# Addendum / Addenda

Project Description / Description de projet <b>U66 U66 New 115KV Dead-End Structure</b>		
Solicitation No./N° de sollicitation <b>17-22089</b>	Project No./N° de projet <b>5078</b>	W.O. No./N° d'ordre de travail <b>A1-011227-03-01</b>
Departmental Representative / représentant ministériel <b>Maurice Richard</b>		Date <b>November 15, 2017</b>
<b>Notice:</b> This addendum shall form part of the tender documents and all conditions shall apply and be read in conjunction with the original plans and specifications.		<b>Nota:</b> Cet addenda fait partie intégrale des dossiers d'appel; toutes les conditions énoncées doivent être lues et appliquées en conjonction avec les plans et les devis originaux.

NRC  
BUILDING U-66  
NEW 115KV SUBSTATION

SK-ADD1-G100

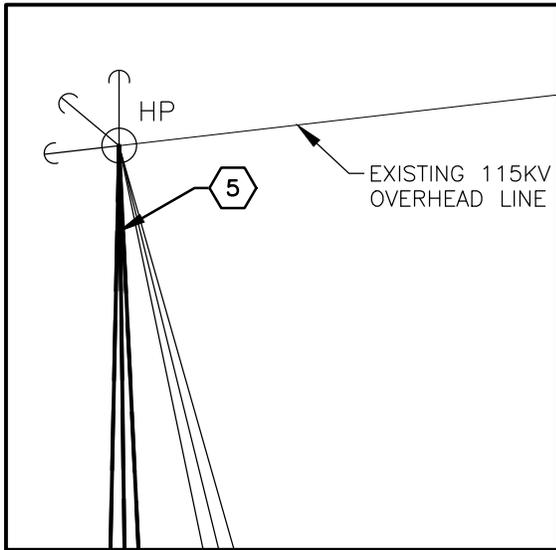
**Answer :** It is the responsibility of the contractor to hire a company to complete locates. Refer to section 01 35 29.06, part 1.18 of the specification.
- Question:** Section 001000 General Instructions subsection 1.12 Working Hours and Security note the normal working hours are from 8 am until 4:30 pm Monday to Friday but Plan #D-5078-G100 Project Specific Notes #2 Indicates that normal working hours are 6 am to 10 pm Monday to Friday. Please clarify which hours are correct.

**Answer:** Addendum #1, sketch SK\_ADD1\_G100 addresses this comment.
- Question:** The question was posed at the site meeting if the insulators at the corner pole were to be replaced as well but we were not provided a definite answer. Can you please confirm if the insulators will or will not be replaced?

1. ALL WORK REQUIRING EQUIPMENT SHUTDOWNS MUST BE COORDINATED WITH THE NRC, AND COMPLETED DURING OVERTIME HOURS. SHUTDOWNS MUST BE COMPLETE 8 HOURS IN ADVANCE OF ~~THE SITE'S REGULAR WORKING HOURS, WHICH ARE MONDAY TO FRIDAY 8AM UNTIL 4:30PM.~~ SHUTDOWNS CANNOT START UNTIL 2.5 HOURS AFTER NORMAL WORKING HOURS.

SK-ADD1-E103

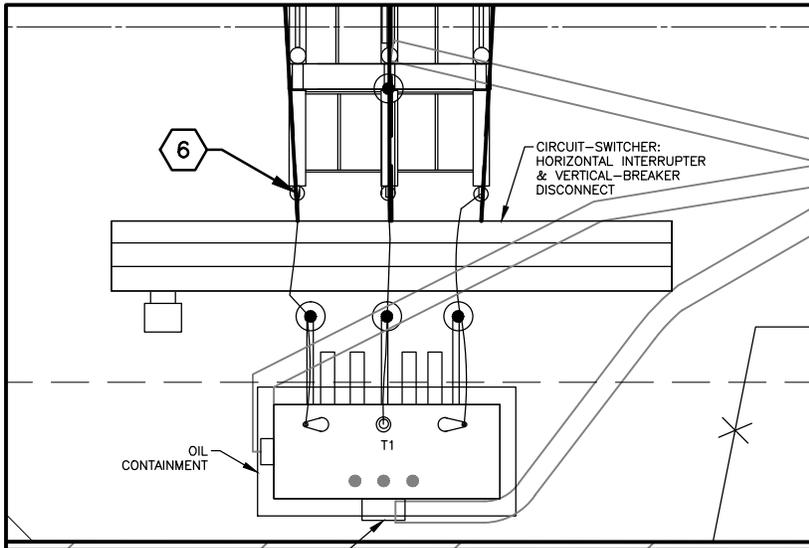
**Answer:** Addendum #1, sketch SK\_ADD1\_E103 addresses this comment.
- Question:** Section 260510 Electrical Testing Subsection 1.1 Scope paragraph 5 indicates the contractor will arrange and pay for all switching and isolation services required from Hydro One. In the site meeting and on the plans it indicates that NRC will schedule the shutdown with Hydro One to Isolate the 115kv line. Will NRC also be taking care of all Hydro One fees?

- 1 CONSTRUCT NEW DEAD END STRUCTURE USING WOOD POLES AS PER SPECIFICATIONS. INSTALL ALL REQUIRED CROSS BRACING AND GUYING.
- 2 SUPPLY AND INSTALL NEW LINE OPENERS.
- 3 SUPPLY AND INSTALL NEW FENCE TO MATCH EXISTING. GROUND FENCE AS PER DETAIL B ON DRAWING E106.
- 4 SUPPLY AND INSTALL NEW 115KV OVERHEAD LINE AND TWO SKY WIRES. ONE SKY WIRE TO BE RUN TO EACH OF THE OUTSIDE WOOD POLES.
- 5 REPLACE EXISTING THREE DEAD END INSULATORS AT CORNER POLE WITH THREE NEW DEAD END INSULATORS.
- 6 REPLACE EXISTING THREE DEAD END INSULATORS AT EXISTING STEEL DEAD END STRUCTURE WITH THREE NEW DEAD END INSULATORS.
